Stream Flow Monitoring Report IV – Salmon Creek

*Annex Creek/Salmon Creek Hydroelectric Project
(FERC Project No. 2307)*

Alaska Electric Light and Power Company

August 27, 2018

Figure 1 – First Quarter 2018 Corrected Discharge

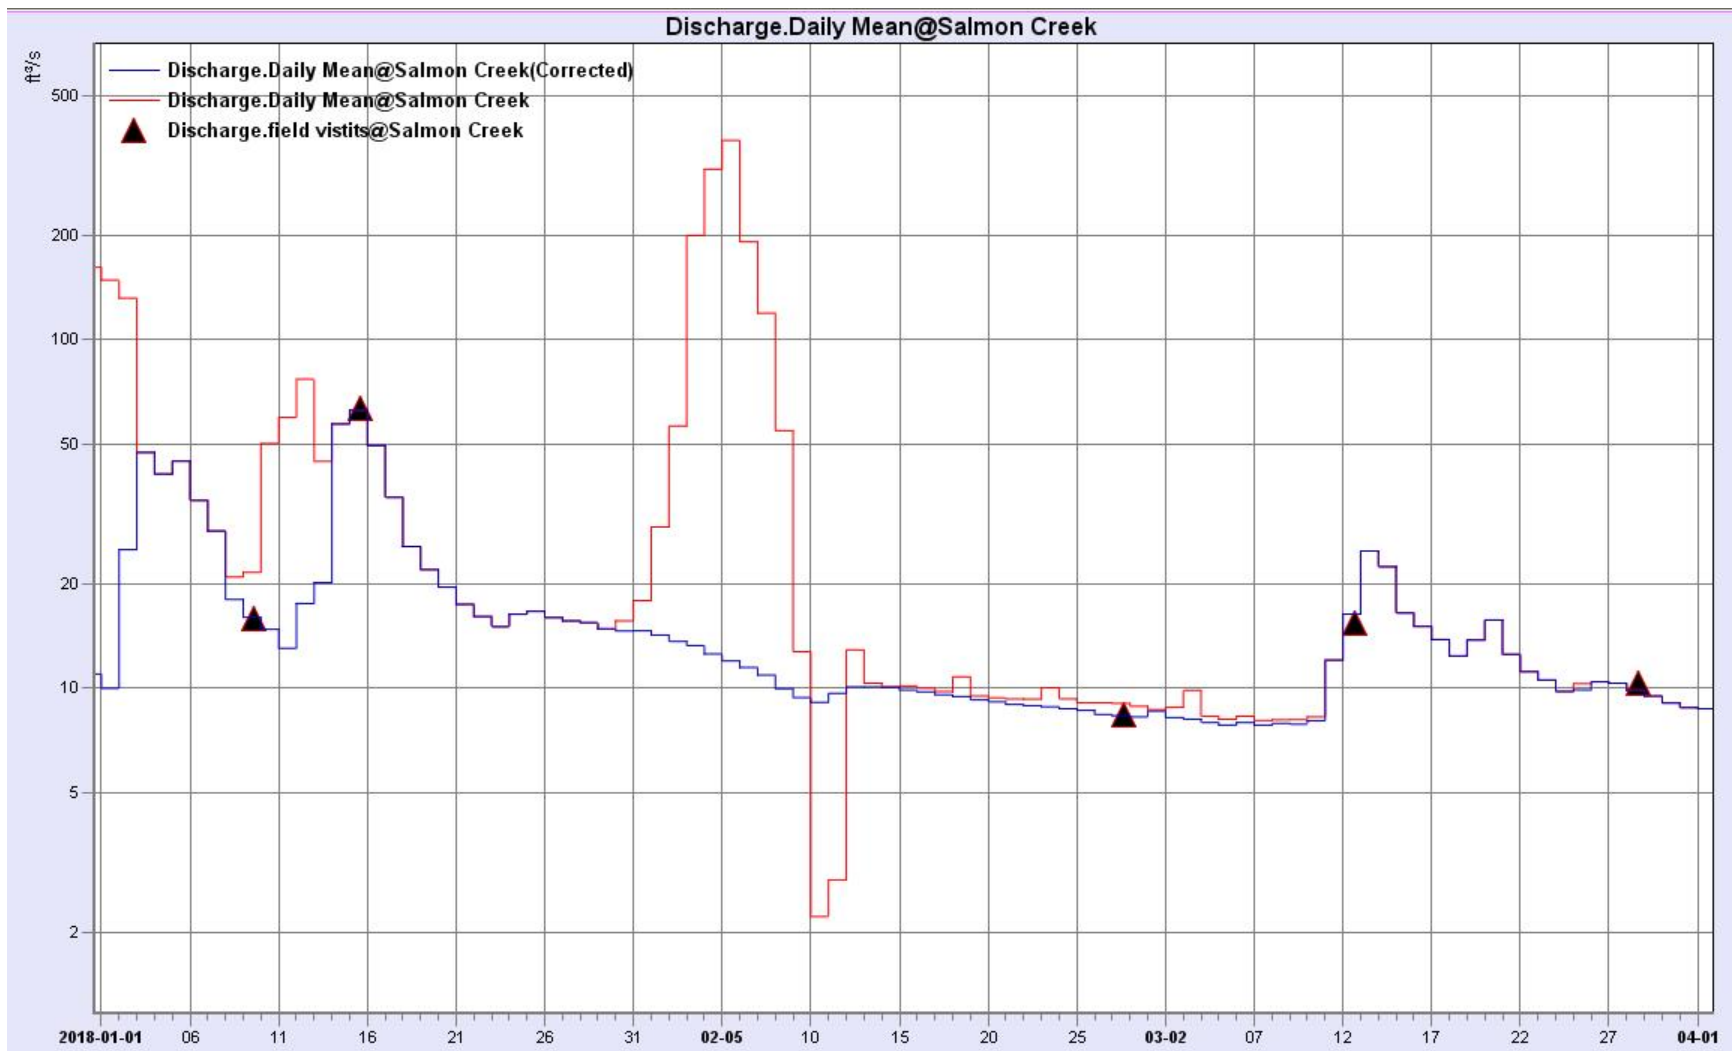
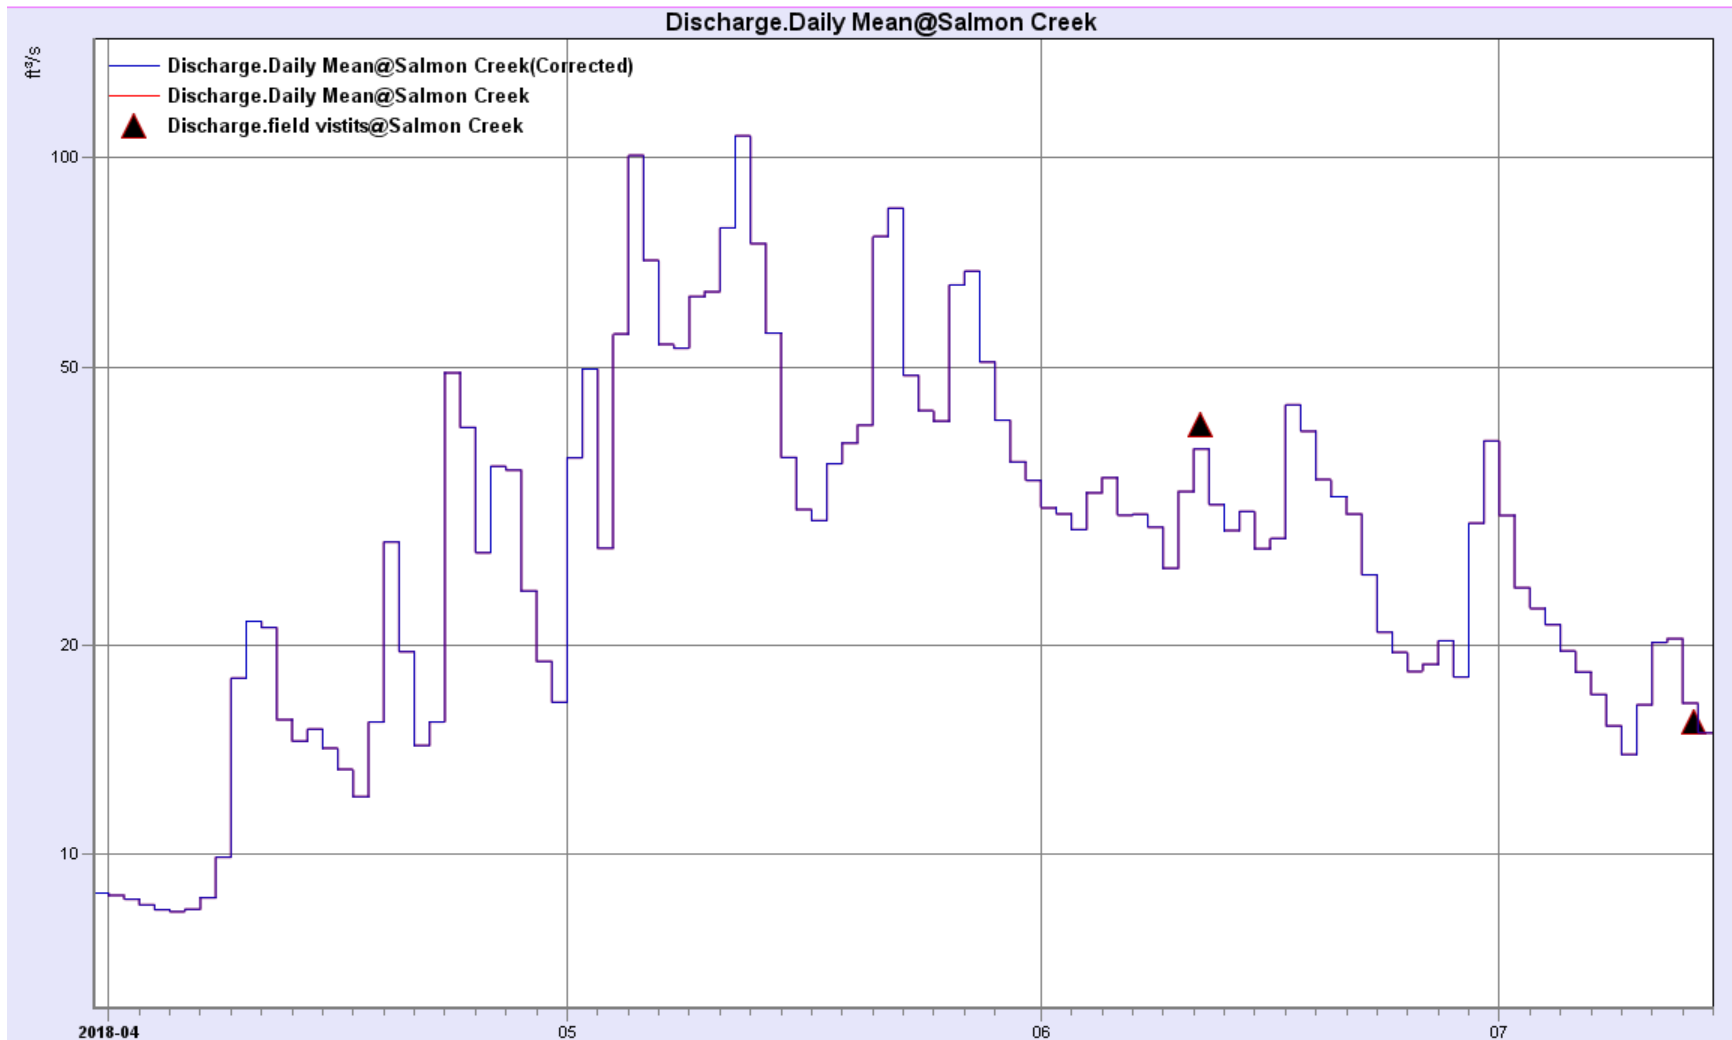
Comments received from ADF&G on August 14, 2017 stated they would like to see discharge measurements taken when flows are less than 25 CFS to ensure the gage accuracy during periods of low flow. Since the primary function of this gage is to alert AELP to flows less than 9 CFS so that supplemental water can be added to the stream, this is a valid concern. The colder drier weather during the first half of 2018 allowed for AELP to collect several low-flow discharge measurements including measurements of 8.4 and 10.4 CFS. Three additional measurements of around 15 CFS were also taken during the first half of 2018. It should be noted, that low flow periods typically occur during the coldest winter periods and that AELP opens the supplemental valve when flows reach 9 CFS and leaves it open until ambient temperatures are above freezing and flow measurements are above 12 CFS.

ADF&G appreciates that 4 discharge measurements were taken at flows below 20 cfs during the 1st quarter of 2018. By regularly verifying that the stage-discharge relationship at low flows has not changed or by applying shifts to the rating curve when the stage-discharge relationship changes, AEL&P and the resource agencies can be confident in the streamgage's accuracy, and thus, its efficacy for identifying when supplemental water needs to be released. Along those lines, it would be helpful if these reports included the rating curve used to calculate Figures 1 and 2, as well as the discharge and stage at the time of the field visits. I believe this information was included as an appendix in the previous Stream Flow Monitoring Report filed with FERC.

Figures 1 and 2 below show the corrected discharge graphs for the first half of 2018. The corrections shown during the first quarter of 2018 are due to backwater from ice, which impacts the operation of the gage, typically resulting in false high readings. The dates of the manual discharge readings are identified in figures 1 and 2. A total of seven discharge measurements were conducted to calibrate discharges for the first half of 2018, including low-flow discharge measurements of 8.4 and 10.4 CFS.
